ACCESSION NBR: 9211090112 DOC. DATE: 92/10/30 NOTARIZED: NO DOCKET #
FACIL: 50-397 WPPSS Nuclear Project, Unit 2, Washington Public Powe 05000397
AUTH. NAME AUTHOR AFFILIATION
SORENSEN, G.C. Washington Public Power Supply System
RECIP. NAME RECIPIENT AFFILIATION
Document Control Branch (Document Control Desk)

SUBJECT: Forwards changes to Section 6 of emergency preparedness plan (EPP), Rev 11 re EALs & Figure 4.2 of EPP, Rev 12 re footnote symbol for CR Supervisor & Shift Technical Advisor positions on subj figure entitled, "...Organization."

October 30, 1992
G02-92-245

Subject: WNP-2, OPERATING LICENSE NPF-21
CHANGES TO THE WNP-2 EMERGENCY PREPAREDNESS PLAN

FIGURE 4-2. NORMAL WNP-2 OPERATING ORGANIZATION

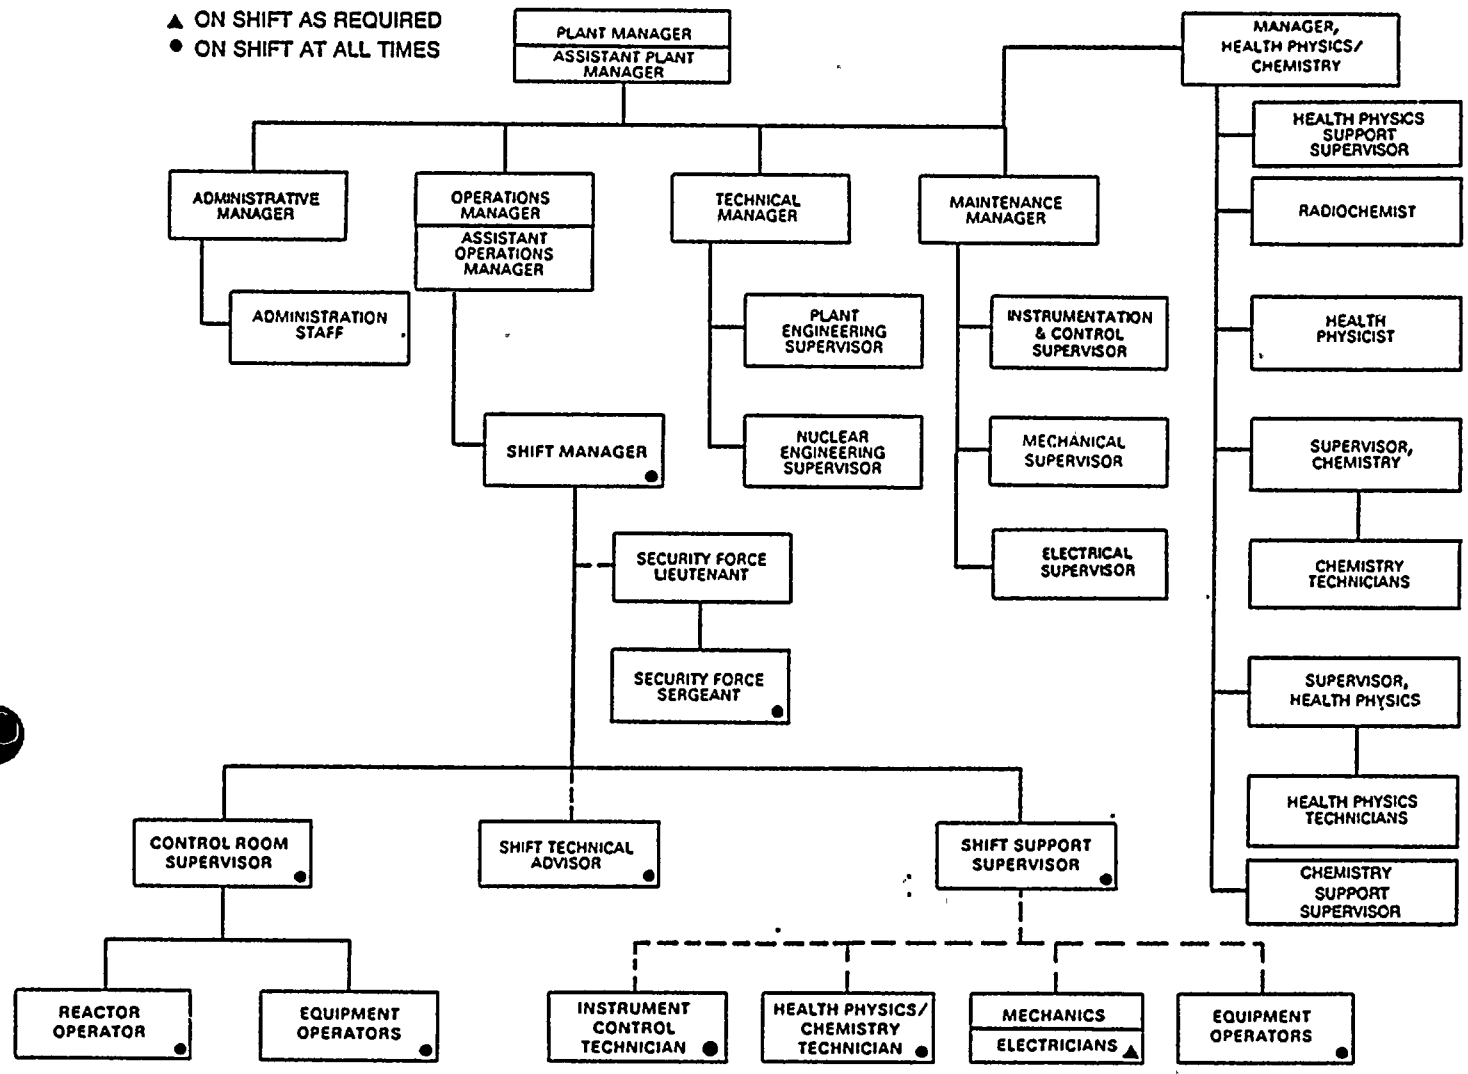
Figure 4.2 of our EPP is an organizational chart that represents the normal WNP-2 operating organization. By footnote symbol on that chart we had indicated that our Control Room Supervisor (CRS) and Shift Technical Advisor (STA) positions were on shift at all times.

This is not a correct representation of how we are operating. In accordance with our Technical Specification Table 6.2.2-1, the CRS and STA are required to be on shift for operating Modes 1, 2 and 3. They are not required to be on shift in Modes 4 and 5.

The Supply System proposes to change the footnote symbol for the CRS and STA positions on the Figure 4.2 chart to reflect "On Shift As Required", rather than "On Shift At All Times".

▲ ON SHIFT AS REQUIRED
 ● ON SHIFT AT ALL TIMES
